Please title this as Final Drainage Report. Per DCM a drainage letter is only allowed where a complete drainage report has been previously approved.

**DRAINAGE LETTER FOR
MOUNTAIN STATES PIPE AND SUPPLY
ELY 631.22 FT OF TRACT 5 AKERS ACRES SUB NO 1, EX THAT PT TO
COUNTY BY REC #210051876
7765 ELECTRONIC DRIVE
COLORADO SPRINGS, COLORADO**

JANUARY 2020

EXISTING AND PROPOSED DRAINAGE
TMC DESIGN CORPORATION PROPOSED RECONFIGURATION
COLORADO SPRINGS, EL PASO COUNTY, COLORADO

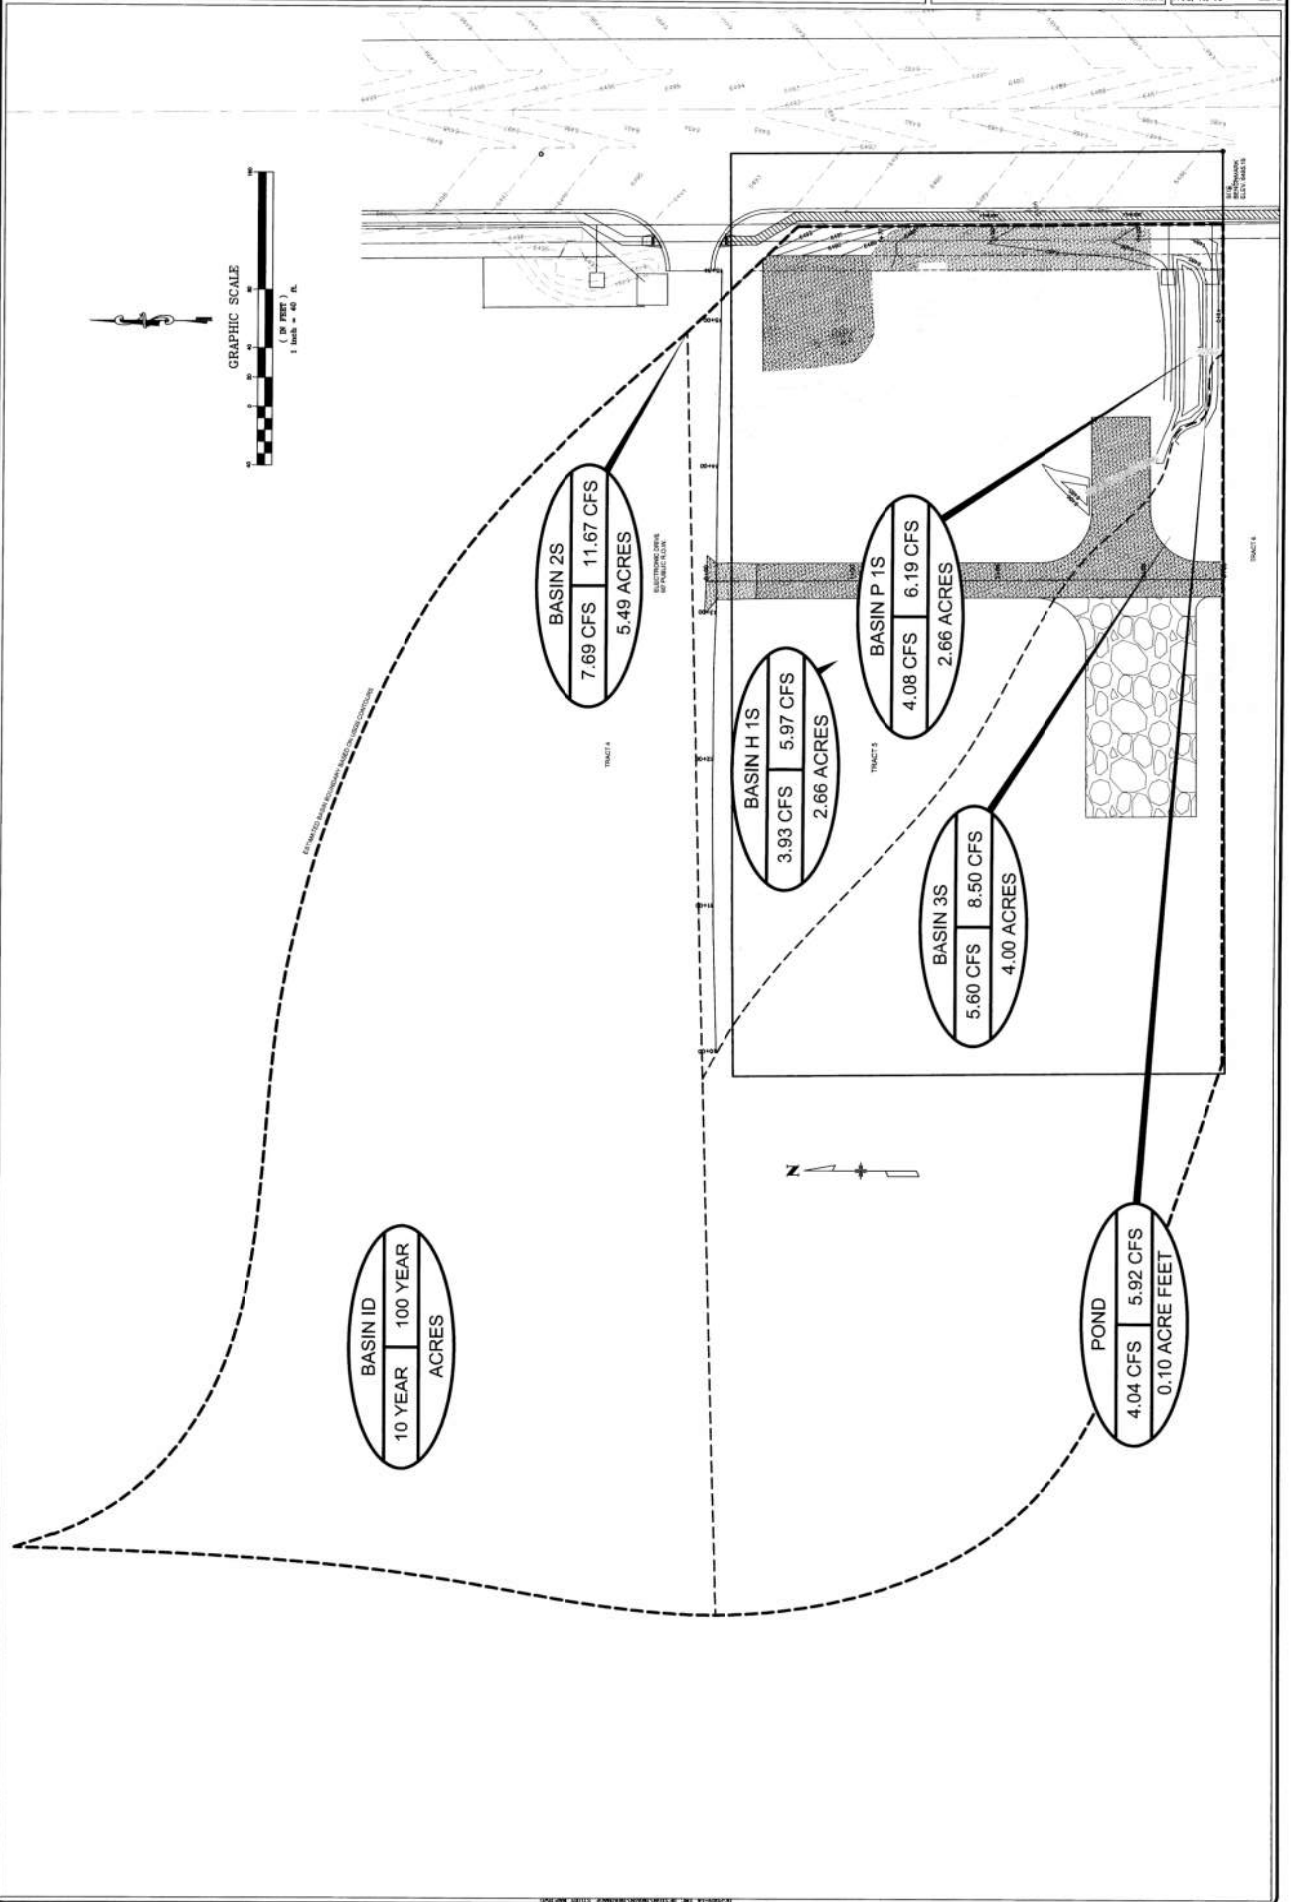
There is no record that this report was ever approved by the County. Please provide a statement regarding this.

There is no record of this drainage report ever being approved. You may compare and reference this report but you shall provide your analysis/design calculations for the existing drainage conditions. Please revise/update the design accordingly.

EXISTING DRAINAGE MAP

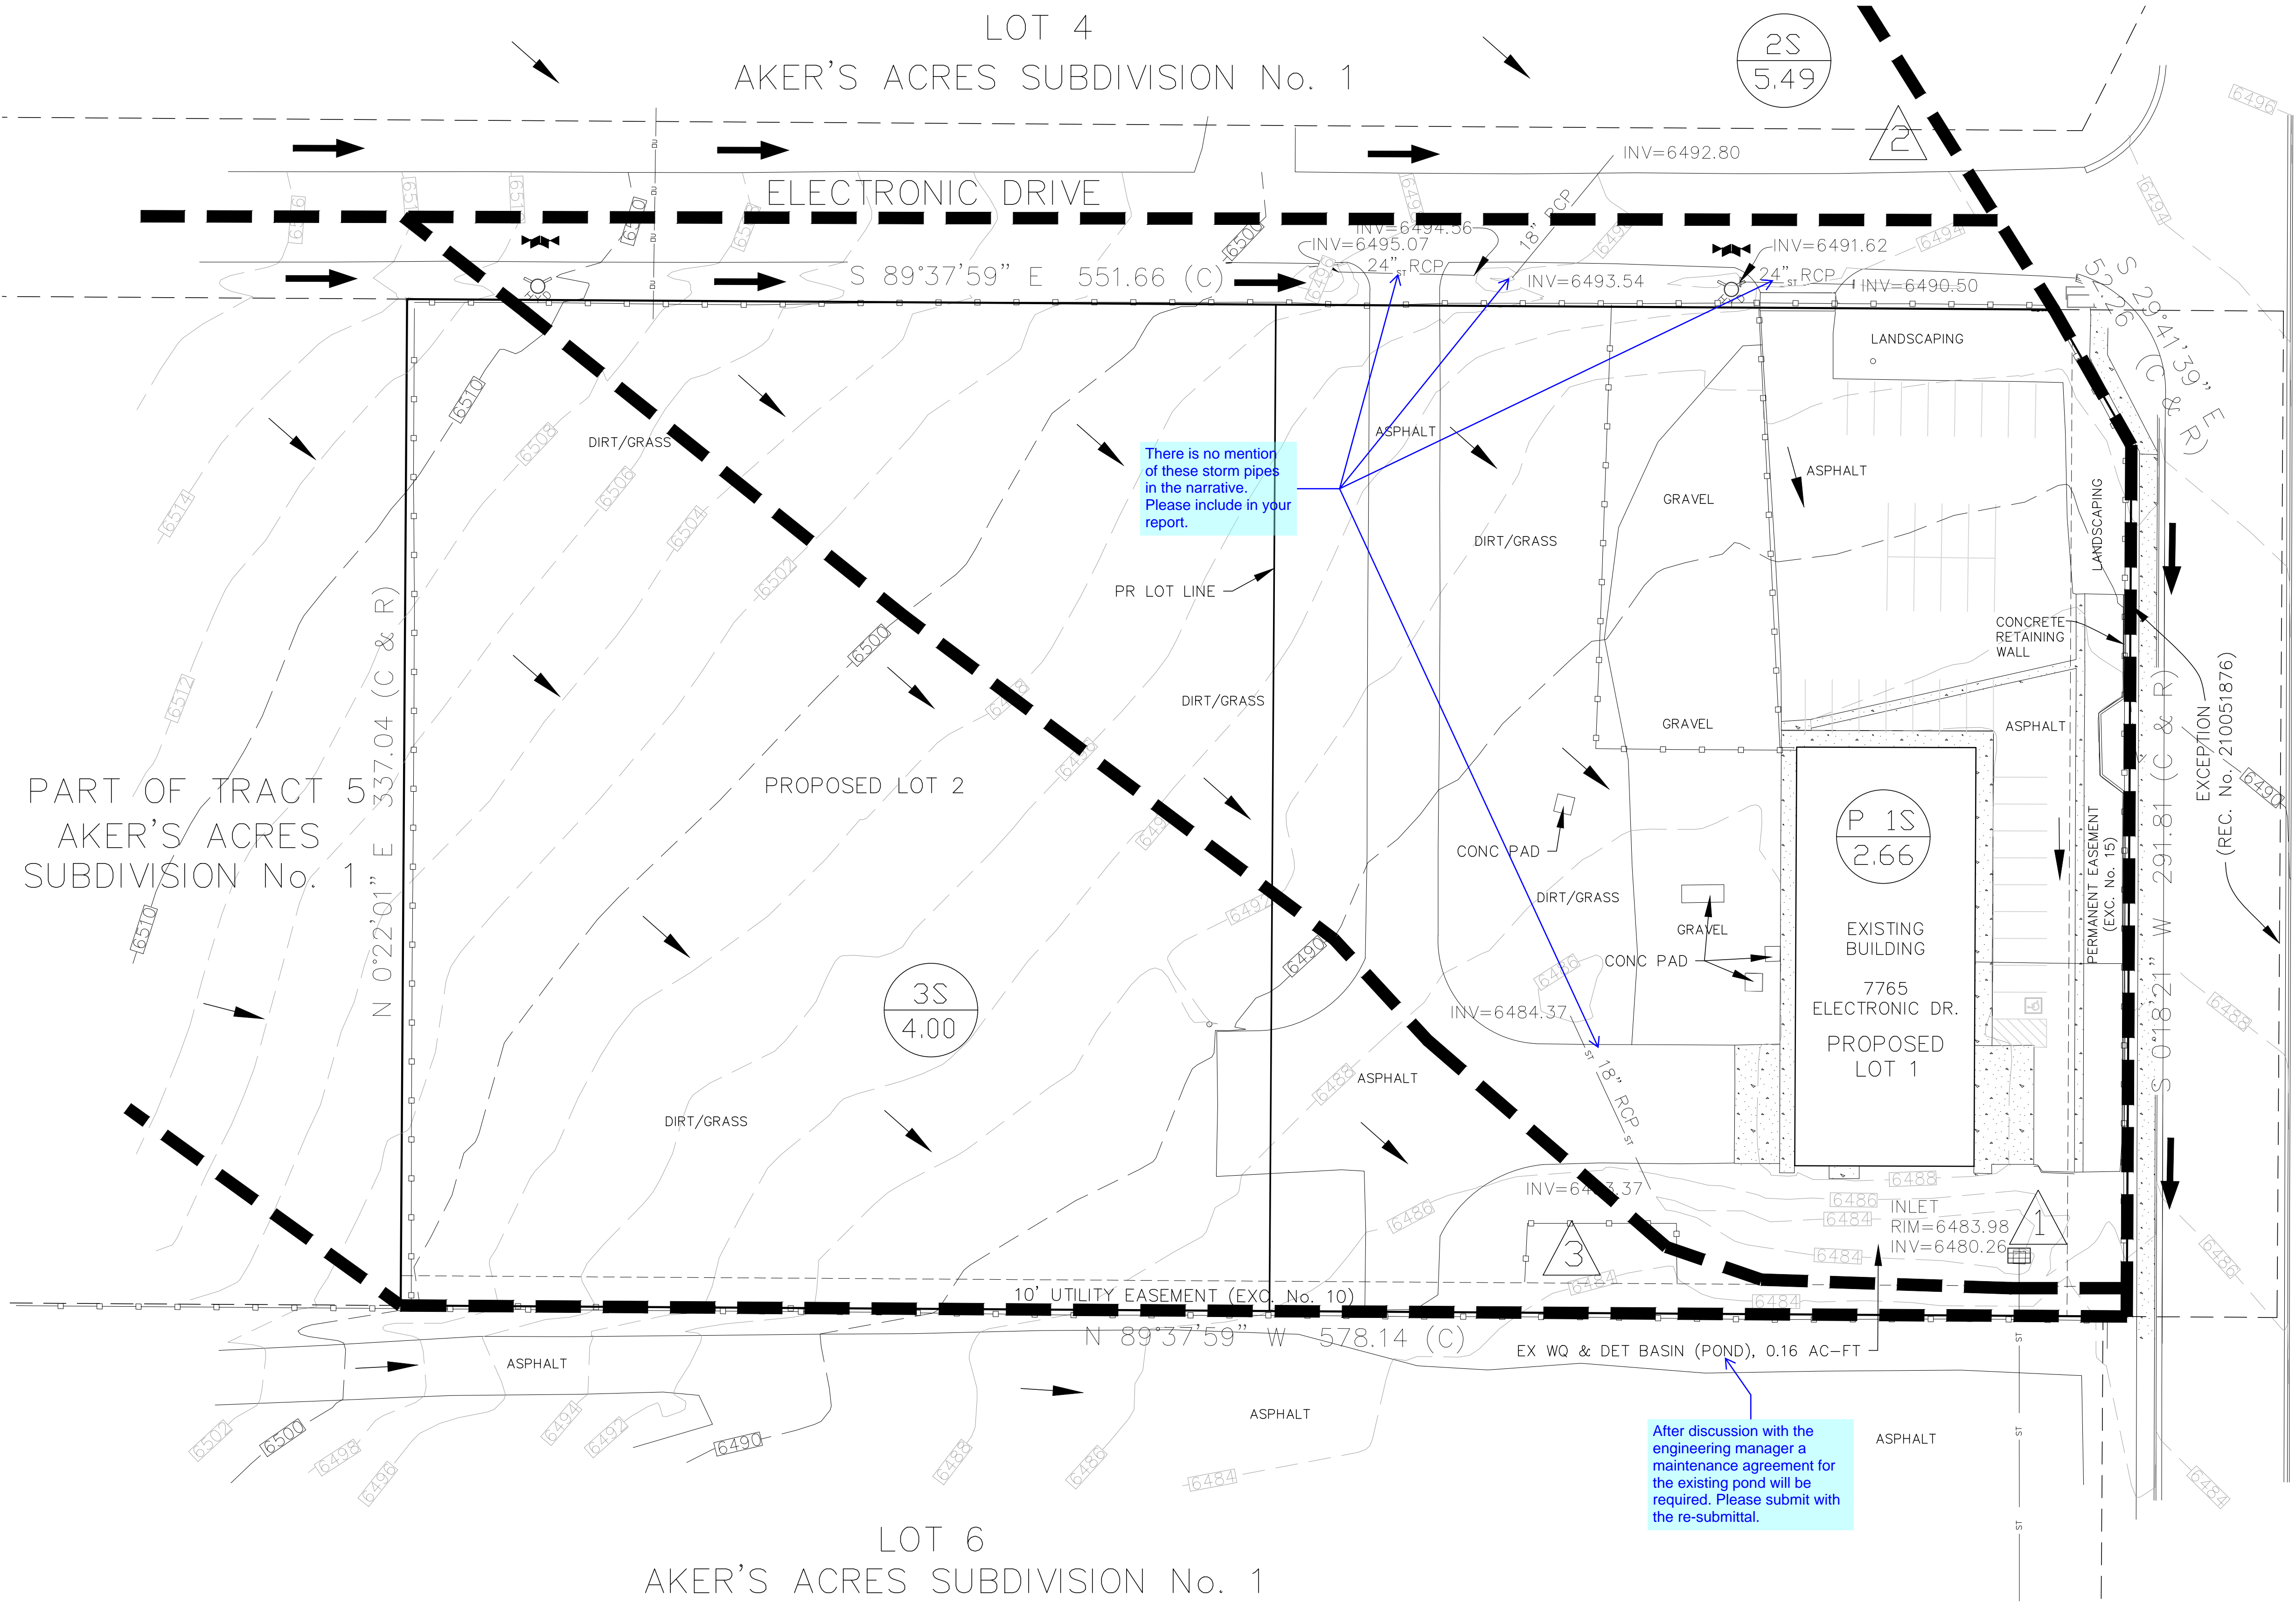
Does any flow from the swale enter the site? There are culverts shown at the driveways yet no mention of them in your report. Please elaborate on the drainage conditions of the site.

Per the drainage plan it appears that the runoff in the pond drains to an inlet/outlet structure and then a storm sewer that goes south. Please include information regarding the outfall of the pond.

Please indicate where the design points discharge to.
